AGENDA - LPP

Meeting:	Georges River Local Planning Panel (LPP)
Date:	Thursday, 20 June 2019
Time:	4.00pm
Venue:	Council Chambers, Civic Centre, Hurstville
Panel Members:	Paul Vergotis (Chairperson) John Brockhoff (Expert Panel Member) Michael Leavey (Expert Panel Member) George Vardas (Community Representative)
Council Staff:	Meryl Bishop (Director Environment and Planning) Nicole Askew (Coordinator Development Assessment) Cathy Mercer (PA to Manager Development and Building) Sue Matthew (Team Leader DA Admin) Monica Wernej (Admin Assistant)

LPP Report No	LPP015-19	Development Application No	DA2018/0462
Site Address & Ward Locality	87 Woronora Parade Oatley Mortdale Ward		
Proposed Development	Demolition works and construction of detached dual occupancy with swimming pool and cabana on each lot		
Owners	365 Project Management Pty Ltd		
Applicant	J Chen		
Planner/Architect	ARC Homes Australia		
Date Of Lodgement	6/11/2018		
Submissions	28		
Cost of Works	\$740,000.00		
Local Planning Panel Criteria	The development has received more than 10 unique submissions by way of objection.		
List of all relevant s.4.15 matters (formerly s79C(1)(a))	State Environmental Planning Policy No 55 –

Figure 1 - Proposed Site Plan - 87 Woronora Parade, Oatley

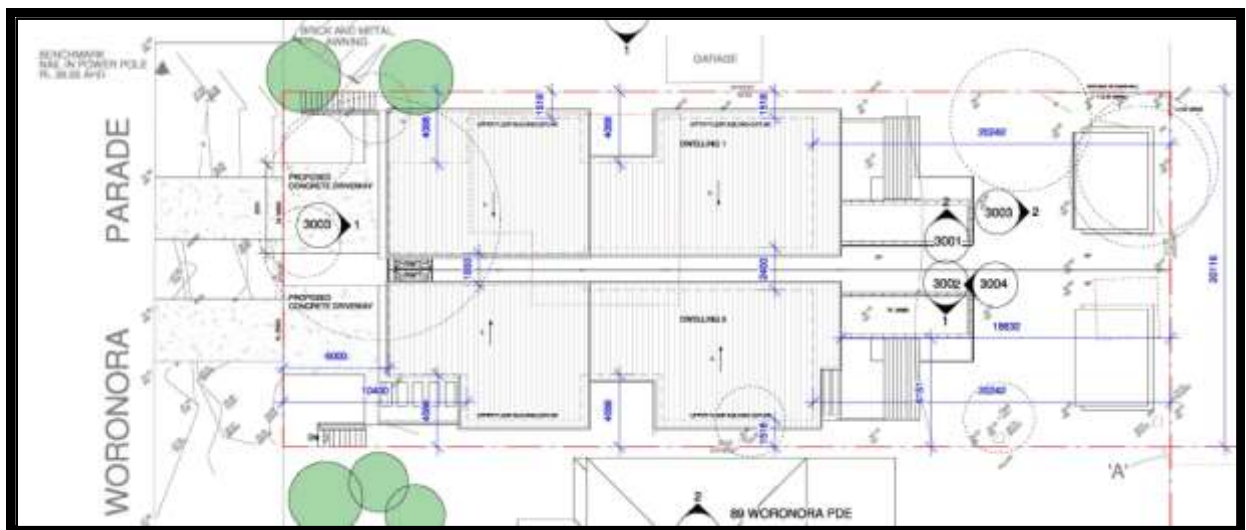
33. However, the subject site has a lot width of less than 22m, being 20.115m. The resulting developments built form will not respect the streetscape bulk and scale of development in the immediate locality and therefore inconsistent with the precinct. In addition the development does satisfy other development criterion of Council's Development Control Plan.

46. Hurstville DCP No 1 requires a minimum of 25% of site area to be landscaped open space as the allotment is in the Foreshore Scenic Protection Area (FSPA). The proposed landscaped area is less than 25% of the site. As a result, it fails to satisfy the numeric criterion and the objectives of the control namely; '*provide landscape amenity to the dwelling*' as prescribed in DCP No 1 and fails to adequately satisfy the R2 Low Density Residential objective '*to encourage greater visual amenity through maintaining and enhancing landscaping as a major element in the residential environment*'. The development also fails to satisfy the objectives of Clause 6.4 Foreshore Scenic Protection Area as referenced in the HLEP 2012 to reinforce the dominance of landscaping over built form.

53. The application has failed to provide a development that is suitable for the site with respect to site frontage, streetscape, landscaping, bulk and scale and vehicle access. For the reasons detailed in this report, the application cannot be supported.

Figure 2 - Proposed Front Elevation – 87 Woronora Parade, Oatley

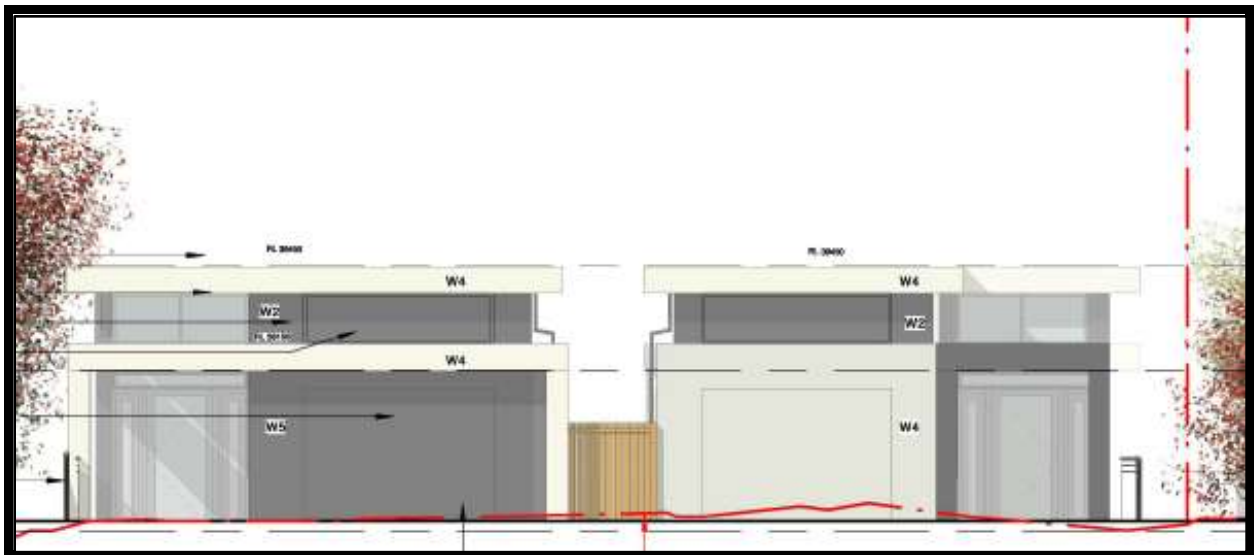
45. Hurstville DCP No 1 requires the street façade of dual occupancies to adopt an asymmetrical design to provide each dwelling with an individual identity when viewed from the street. The proposed front façade provides a mirror-reverse design for the detached dual occupancy. It is considered the proposal fails to satisfy the objective of the clause as the design does not '*contribute to the creation of cohesive yet varied and visually interesting*' and is '*inconsistent with the preferred future character of the area streetscapes*' as prescribed in DCP No 1. It is noted the applicant attempted to achieve asymmetrical design by providing differing colours to the two (2) dwelling façades. However, using colour differentiation is not considered to be an acceptable solution to satisfy the requirement for an asymmetrical design.

Comment: The development design and form is inconsistent with the streetscape of the locality. The development has not had regard to the design criteria for dual occupancy developments. The development is therefore inconsistent with the existing built form and character of the area and has failed to provide an asymmetrical design to provide each dwelling with an individual identity when viewed from the street.

Figure 6 - Elevational Shadow Diagram of 89 Woronora Parade, Oatley (Source: ARC Homes)

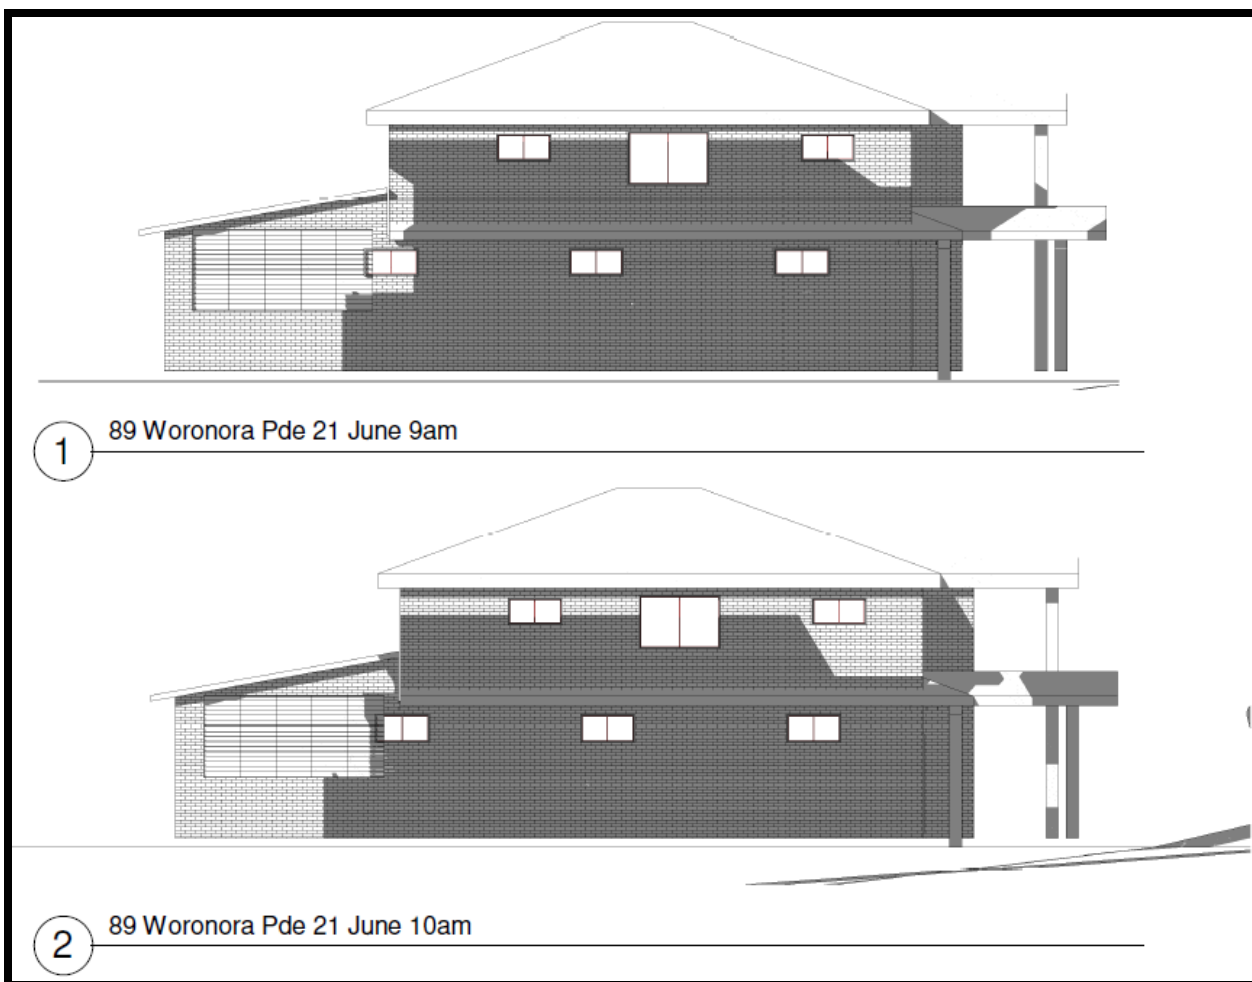
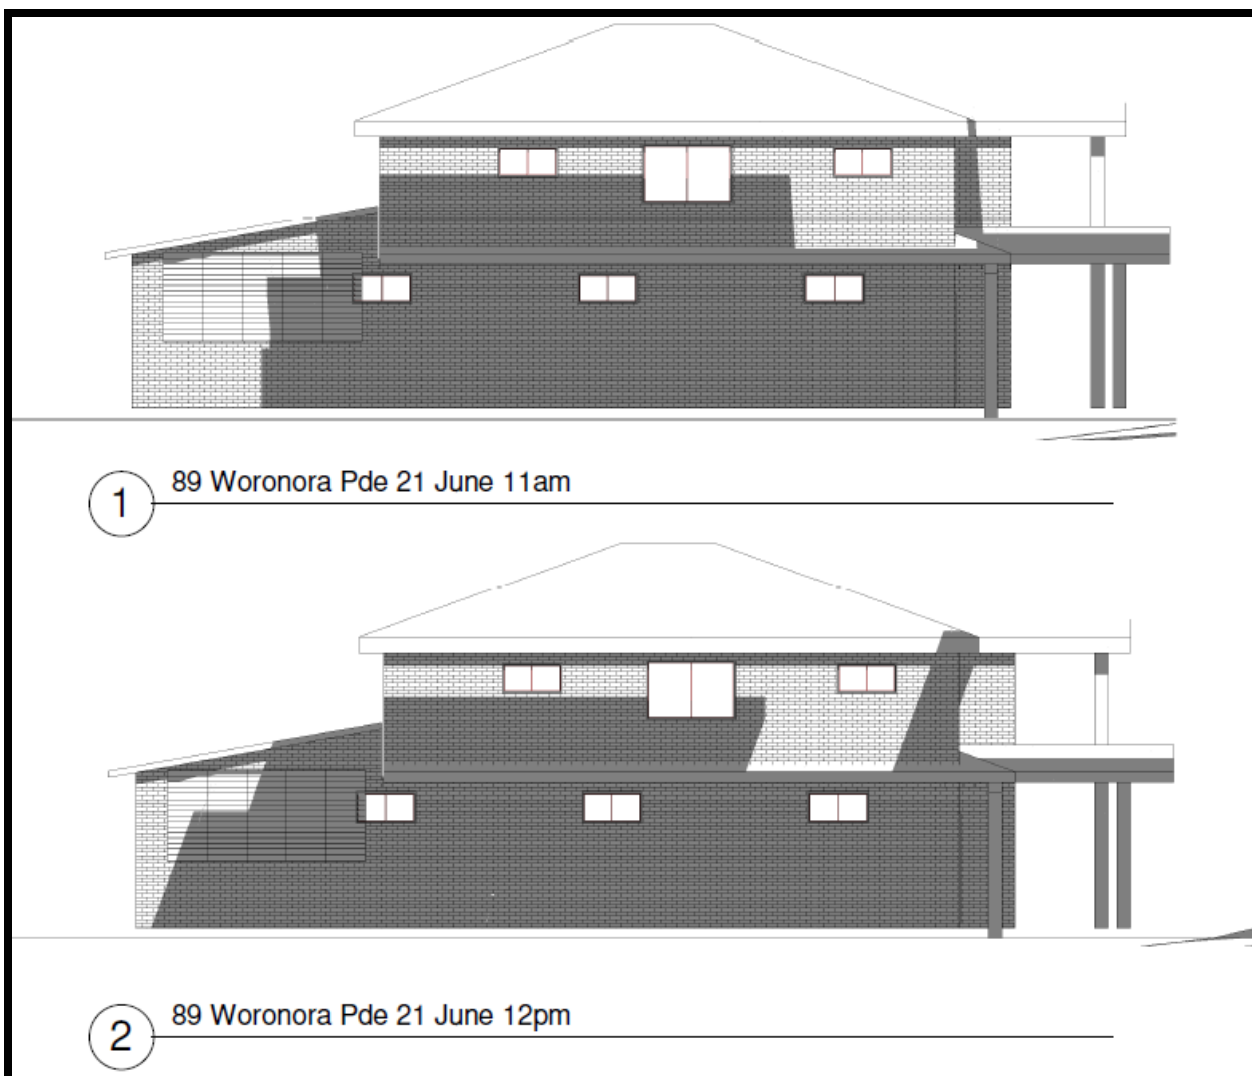
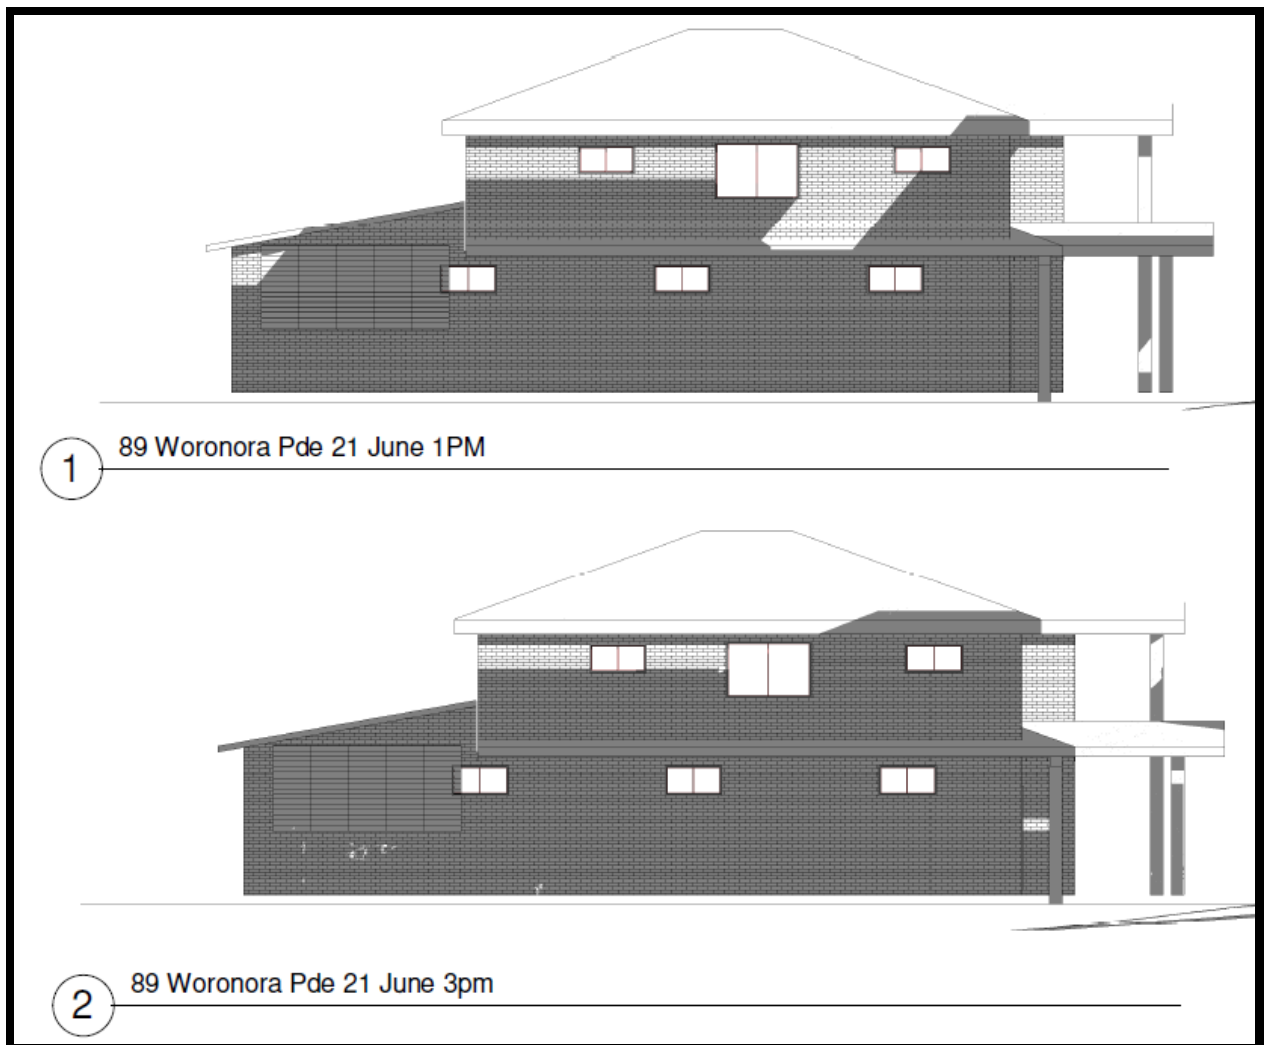
40. However, in this case, the exemption clause cannot be invoked as the development contains various non-compliances, including building height non-compliances, which result in increased overshadowing. The unnecessarily increased overshadowing could be mitigated with a more conservative design.

Comment: As discussed above, the development contains various building height non-compliances, which result in increased overshadowing. The overshadowing resulting from the development could be lessened with a better, more compliant, less obtrusive design. The development is considered to be unacceptable in this regard.

Figure 18: Modified Windows

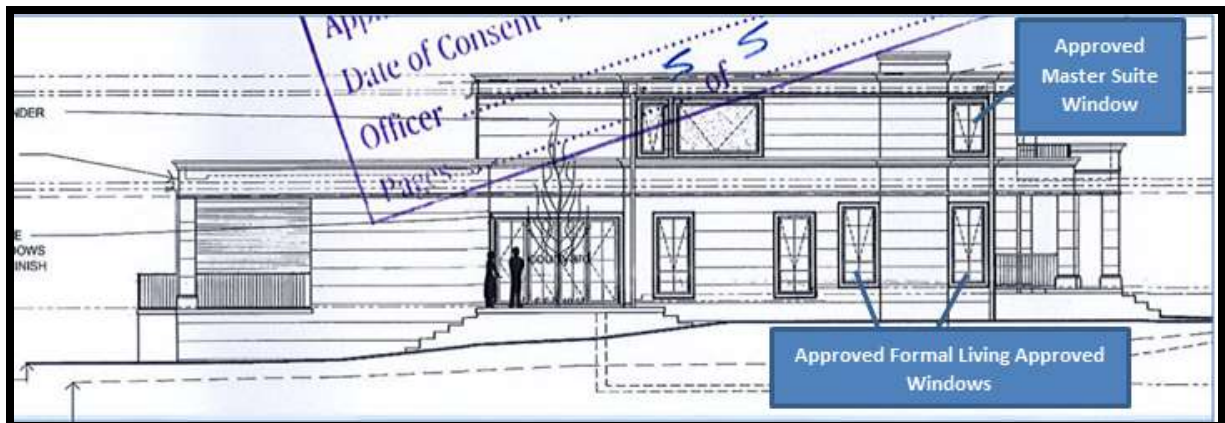
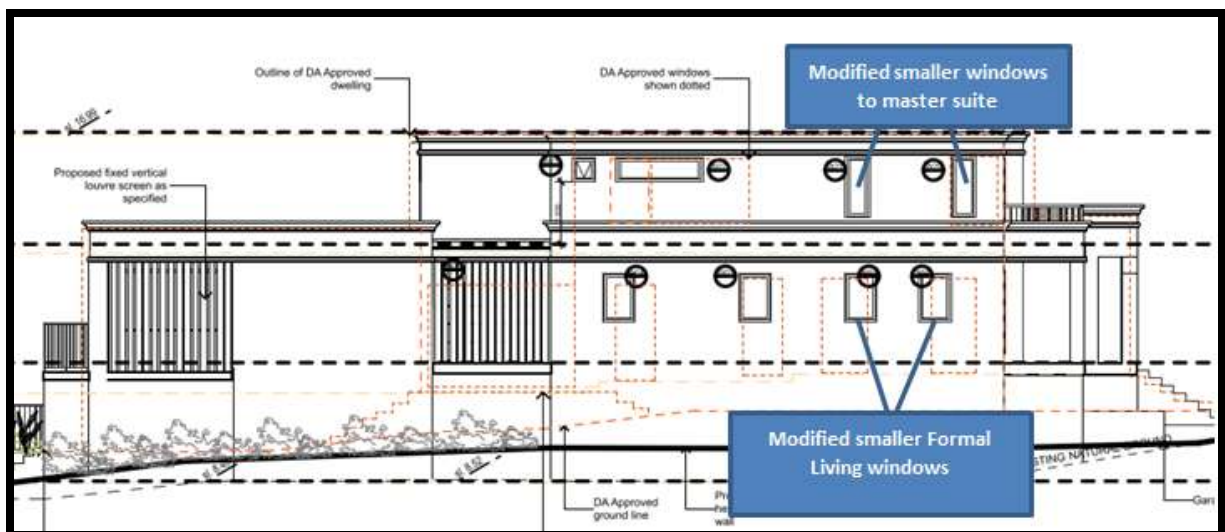
84. It is considered the variation is unlikely to result in any adverse privacy impacts given the non-compliant component overlooks a blank wall and the roof top of the dwelling to the north. In addition the following changes have been made:

- two (2) larger windows to the formal dining and rumpus room on the ground floor have been replaced with two (2) smaller windows (W01 and W02) with sill heights of 0.95m; and
- one (1) large window to the master bedroom, walk in wardrobe and ensuite on the first floor has been replaced with two (2) narrow windows.

Figure 20: As built/modified northern courtyard

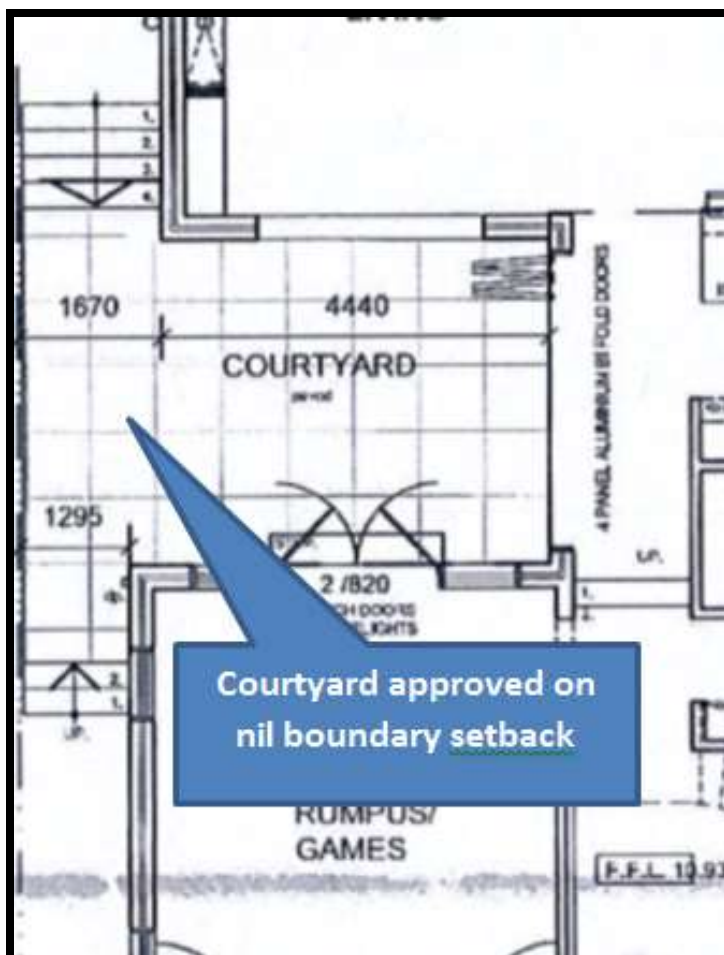
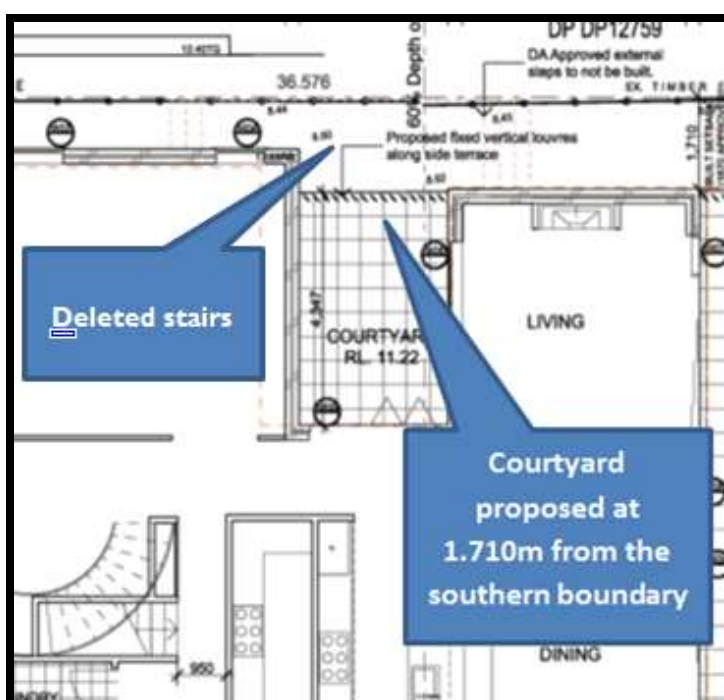
92. To overcome some of the privacy impacts, the as built courtyard has been reduced in size and setback 1.71m from the northern boundary. A fixed vertical louvre privacy screen has been proposed along the northern edge to further minimise any impacts. A suitable condition will be placed in the consent to ensure that the blades of the privacy screen are of an appropriate width and spacing to ensure privacy is maintained.

93. The approved stairs to the courtyard is proposed to be deleted. There is now no direct access from the ground level to the northern courtyard as can be seen below.

Figure 22: Proposed privacy screen on the northern side of the terrace

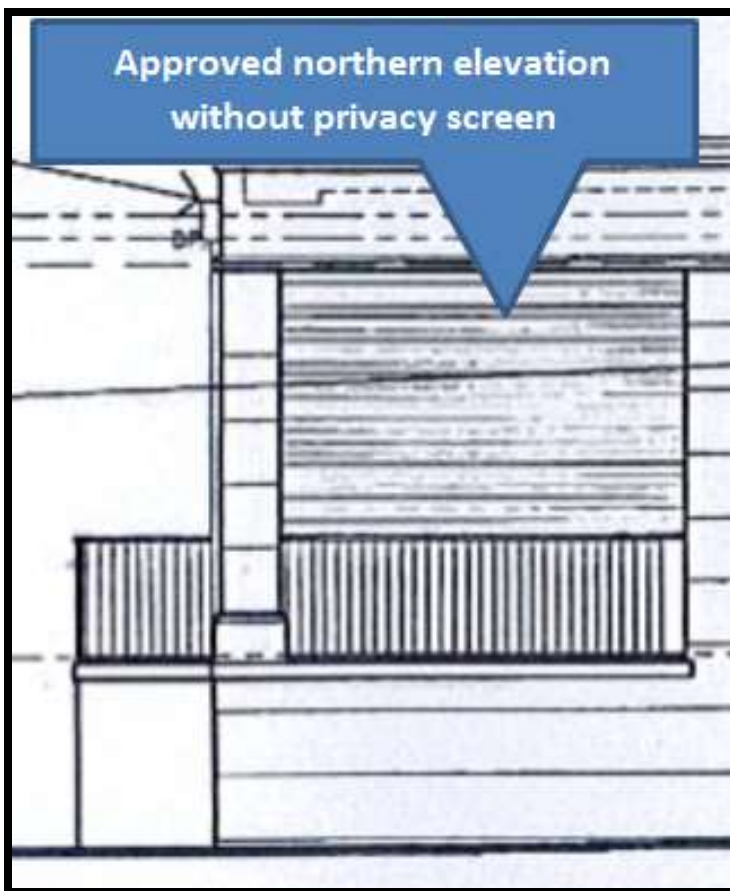
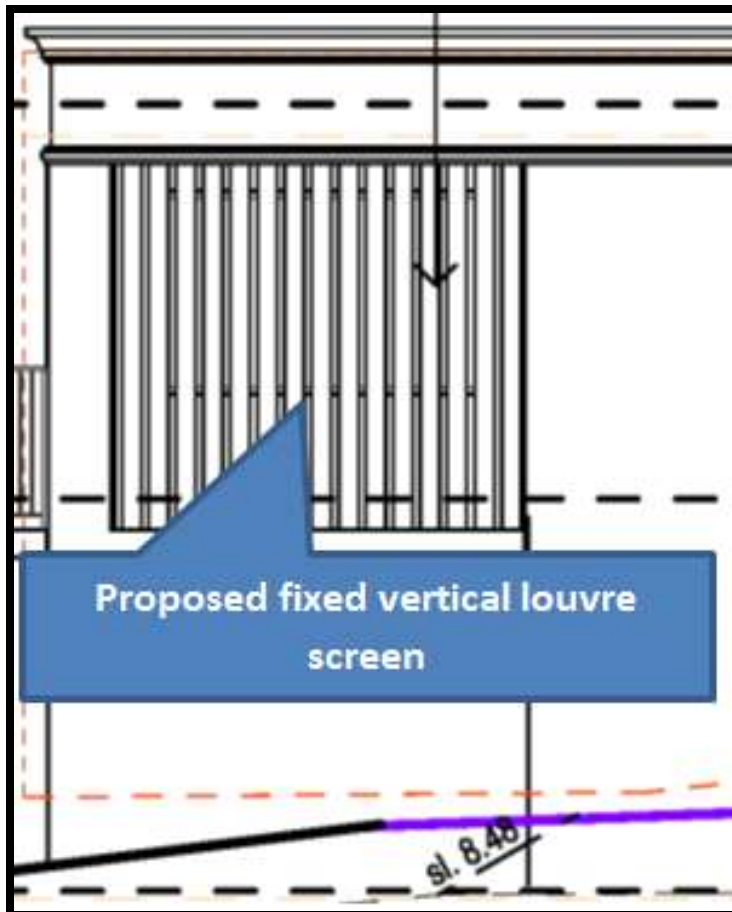
94. The terrace was approved at a finished floor level of RL10.66 above an existing ground level of approximate RL8.22 (2.44m). The FFL of the terrace has been constructed at 0.46m above the approved FFL with an overall height of 2.92m.

95. The elevated nature of the approved terrace will inevitably result in some overlooking on the private open spaces of the side and rear properties. While any further increase to the approved height of the terrace is not desirable, it is considered that the additional impacts as a result of the as built terrace are minimal and as such considered acceptable.
96. As can be seen from the extracts below, the northern side of the terrace was approved without any privacy treatment. The proposal now incorporates fixed vertical louvre screening to minimise overlooking impacts. A suitable condition has been recommended to be included in the consent to ensure that the blades of the privacy screen are of an appropriate width and spacing to ensure privacy is maintained.
